DFE differences between Annex 178A and Clause 180

Norman L. Swenson, Ph.D.
Norman Swenson Consulting
Affiliations: Nokia and Point2
2 March 2026

Figure 178A-9—Receiver discrete-time equalizer

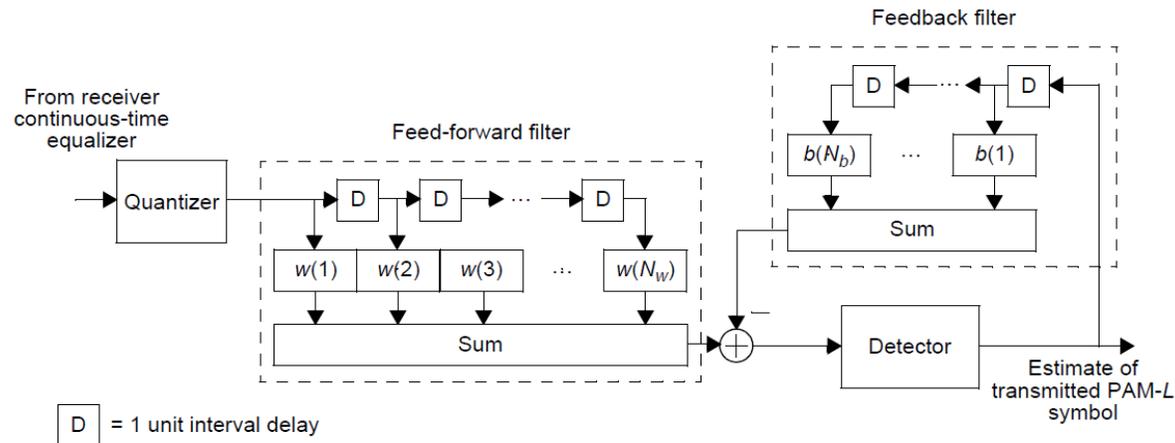
- As the caption says, this is a discrete-time equalizer
 - I would prefer “Sampler” over “Quantizer”; it samples the analog waveform at discrete T-spaced time intervals
- This is the DFE described in most literature and textbooks.
 - Often preceded by a matched filter or sampler is clocked at T/2.
- There is no eye diagram. There is simply one sample per UI.

Figure 180–10—TDECQ reference equalizer functional model

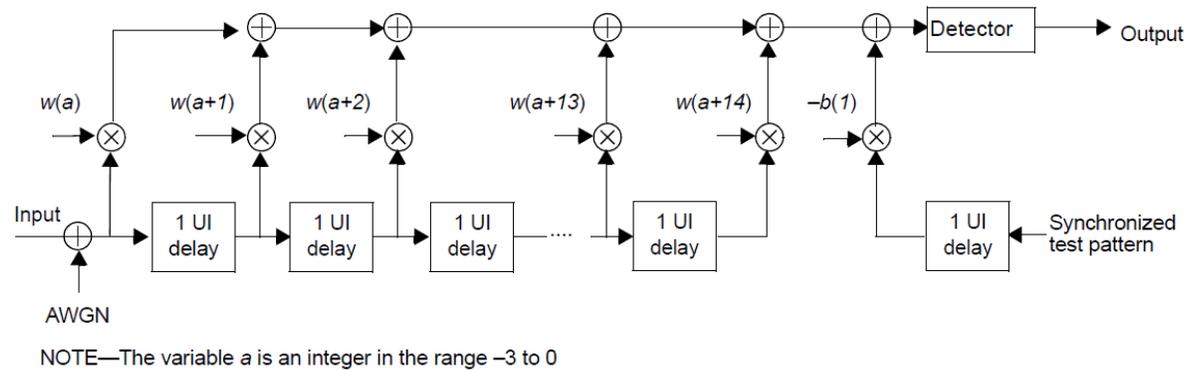
- From 180.9.6.3 Reference equalizer:
“The reference equalizer is a 15-tap, T-spaced, feed-forward equalizer (FFE), followed by a 1-tap decision feedback equalizer (DFE)”
- There is no classic figure of a DFE given in Clause 180
 - Though not explicit, the use of the DFE implies a continuous time equalizer

Figure 180-11—Illustration of the TDECQ measurement

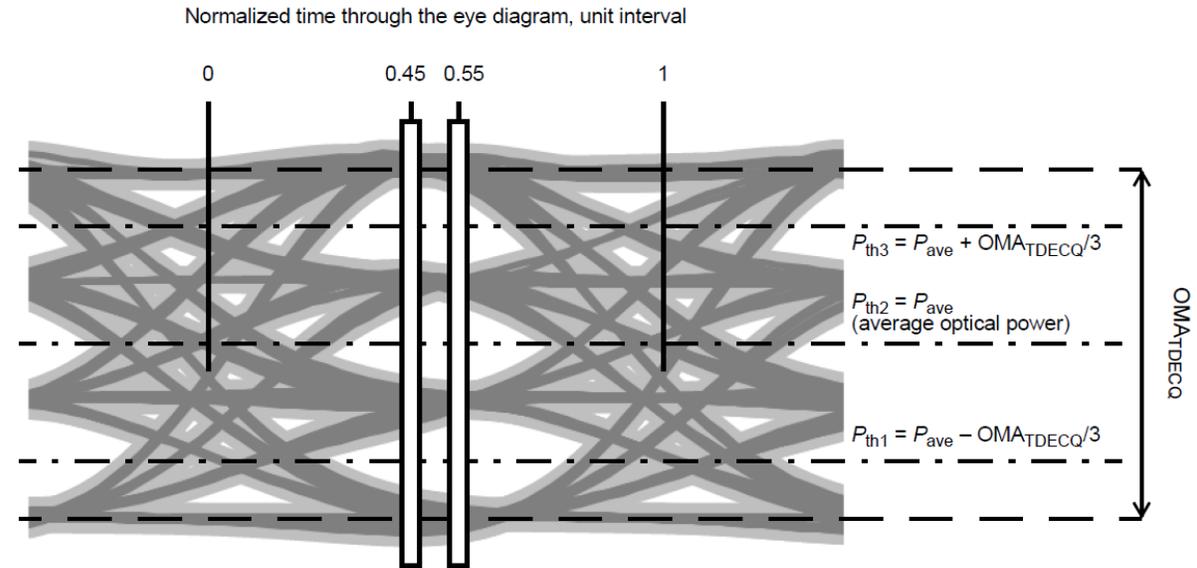
- The description of the TDECQ computation relies on a continuous-time receive eye diagram
 - Clause 180.9.6.4 speaks of zero crossings and “two vertical histograms [that] are measured through the eye diagram”
- The only way to have such an eye diagram is to remain in continuous time until the slicer
- The feedback filter must also be continuous time (unlike a classic DFE)

- Describing the reference equalizer as a “feedforward equalizer followed by a feedback equalizer” is not standard terminology
 - A DFE is normally described as a transversal feedforward filter , a decision element, and a transversal feedback filter – that is, the DFE includes the feedforward section
- The eye diagram of Figure 180-11 should show a discontinuity where the feedback level changes value.

Implied Clause 180 DFE

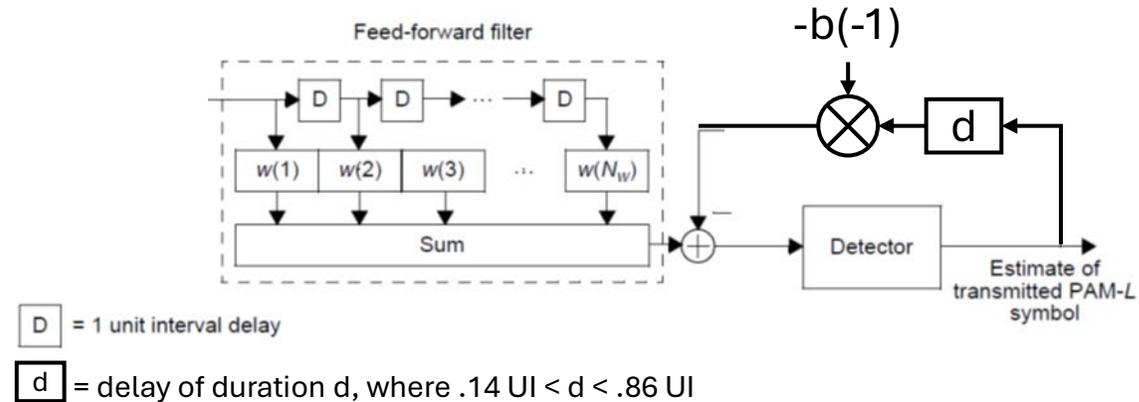
- The signal in this block diagram is continuous time.
- The eye diagram is measured at the input to the detector
- The detector output changes once per symbol period and holds its value until the next decision instance 1 UI later.
- The delay d in the feedback path is not 1 UI for the continuous-time feedback
 - It is bounded by $.14 \text{ UI} < d < .86 \text{ UI}$ to ensure that the feedback changes value before the left vertical histogram slice or after the right vertical histogram slice
 - This representation is consistent with the TDECQ description but does not imply an implementation
